VEHICLE RECALL

G-03506 March 2003

SUBJECT: VEHICLE RECALL (U.S., EXPORT)

ALTERNATOR CABLE TERMINAL MAY BREAK OFF
9100i, 9200i, 9400i, and 9900i models built 6/8/2001
through 11/4/2002

Figure 1

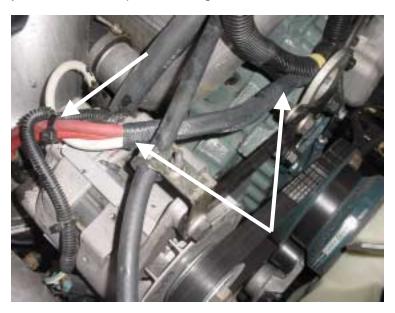
- 2. Remove the negative ground cable from the batteries.
- 3. Remove the tie straps as necessary and pull the conduit on the alternator harness back to the yellow locator tape as shown in Fig 1.
- 4. Remove all tie straps and tape on the alternator cables from the terminal ends to the yellow locator tape. See Figure 1.

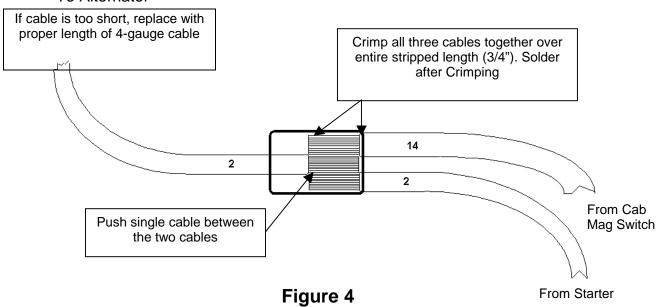
- 7. Using a 3/O barrel splice (AMP #3306), insert all three red cable ends as shown in Figure 4, with the bare wire ends aligned inside the barrel connector. Make sure the number 2 cable is long enough to reach the alternator stud as shown in Figures 7 and 8 and that it can be secured as described in step 16, Figure 8, so it will not vibrate. Do not crimp the connector. Disconnect both the positive and the negative cables from the alternator.
- 8. Inspect the terminal eye on the alternator end of cable number 2 for cracks. Replace the terminal if there are any signs of cracking.

- 9. With the cable ends positioned as shown in Figure 4, crimp the barrel splice over the area where the bare cable ends overlap.
- 10. Solder the wires in the barrel splice connector using a propane torch and 60/40-rosin core solder. Make sure the joint is hot enough to allow the solder to flow evenly between the three cables. Make certain the heat from the torch does not melt or ignite other components.
- 11. Center a 3 inch long piece of ¾ inch diameter heat shrink tubing over the barrel splice and heat the tubing uniformly with a heat gun until it has shrunk tightly around the splice and wires. See Figure 5.

Figure 8

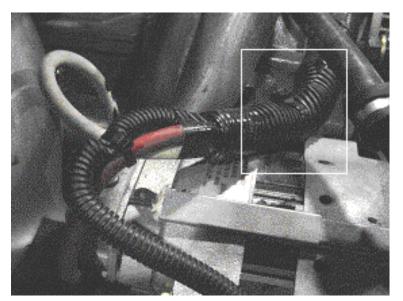
- 14. Connect the white ground cable and the red number 2 positive cable to the alternator.
- 15. Reinstall the conduit around the alternator harness. Tape the conduit at the alternator end and at the barrel splice. See Figure 8.

16. Tie strap the harness to the alternator case bolt and engine lift bracket. Use 3/8-1/2" wide tie straps. See Figure 8 and IMPORTANT NOTE below and make sure the cables do not rest against the alternator case.

Tie strap the harness to the alternator case bolt as shown in the box in Figure 8 using a large 3/8 to ½ inch wide strap. This will hold the harness tight to the alternator and control vibration.
